OFFICIAL NOTICE AND AGENDA
Pardeeville Plan Commission Regular Meeting
Pardeeville Village Hall – Board Room
114 Lake Street, Pardeeville, WI 53954
Tuesday, March 19, 2024 – 6:00 PM

Public Works Director Memo

Topic: Sunrise Subdivision

To: Village of Pardeeville Village Board
From: Joe DeYoung, P.E.; Brad Vowels-Katter, Associate Planner
Subject: Sunrise Subdivision, Lots 17-19 PUD GDP Review
Date: Tuesday, March 12, 2024

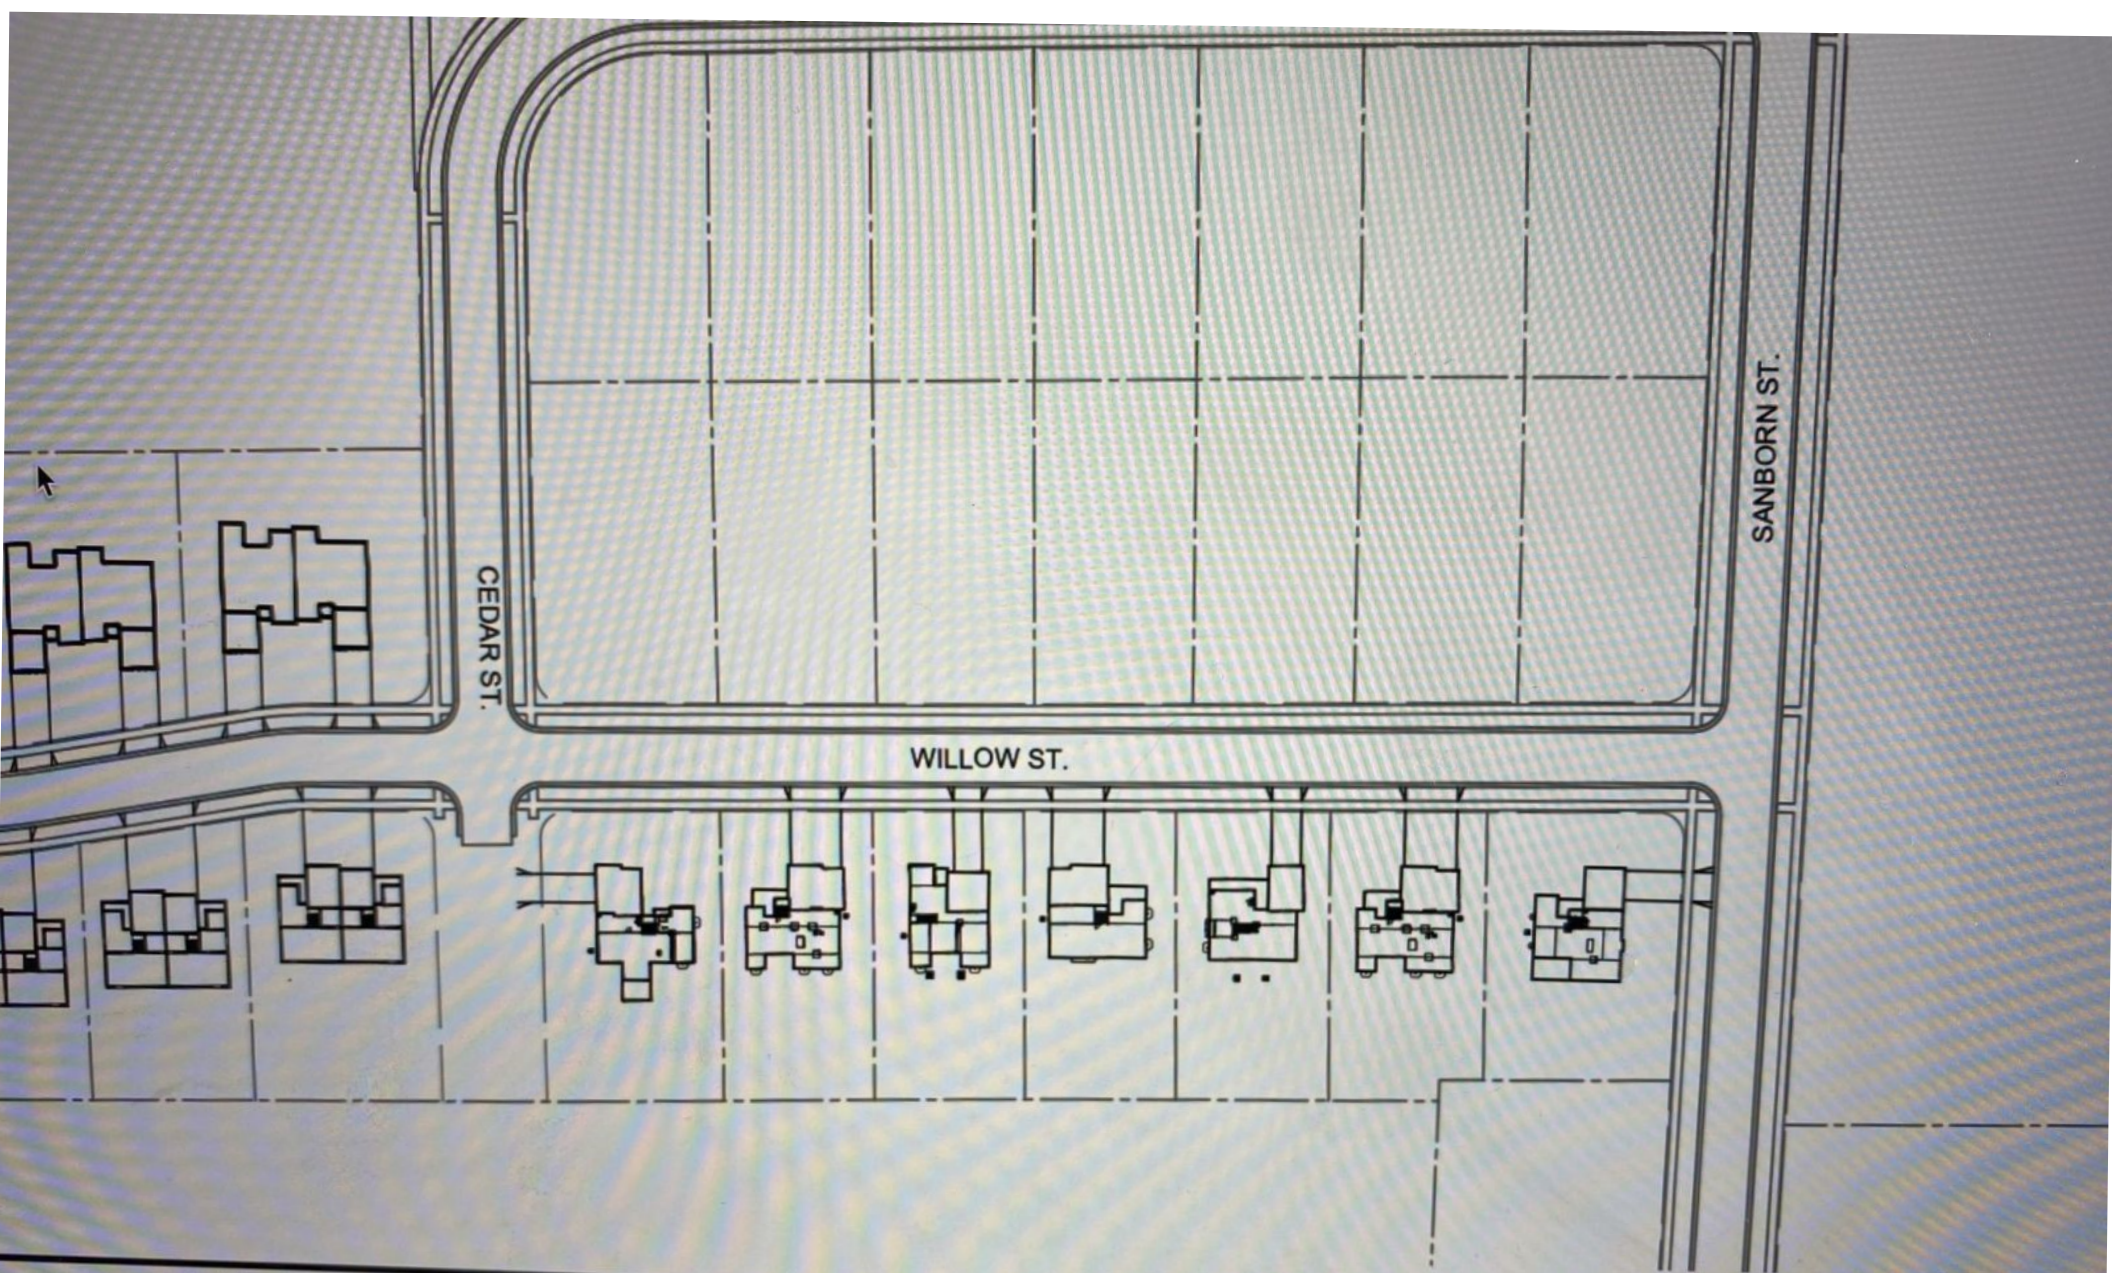
The developer is looking to move driveway access from Willow to Cedar on the lots at the intersection of Cedar and Willow and the same idea at the Willow and Sanborn intersection. While staff does feel that it could be feasible with the lots on Sanborn and the lots on the northern side of the Cedar-Willow intersection. However, staff does not recommend allowing this change for the lots on the southern side of the Cedar-Willow intersection. Due in part, for the unconstructed condition of the road. At the intersection, the Village's ROW extends south but the roadway is not improved south. It is, for all intents and purposes, an open field. There is no subgrade work, base work, utilities in, or proper grading to account for the traffic that we would be routing onto this portion of the road. Granted it would only be one lot, but that would require Village to maintain this section to a greater degree than originally required. Currently, the maintenance of this would only be mowing periodically. Likewise, it poses a potential safety risk due to the minimal accessibility, especially in the event of an emergency and winter maintenance going down that small dead-end would be difficult. Furthermore, as the Village, it has a role to protect and serve the residents of the Village, it is staff's opinion that this change would not meet the Village's goal. By allowing this change, the impact of future construction on this homeowner will be substantial.

Should you agree with the opinion documented above, a motion would be in order to recommend the Village Board approve of the driveway change for the Willow-Sanborn intersection and the northern Willow-Cedar intersection but not approve the driveway change on the southern side of the Willow-Cedar intersection.
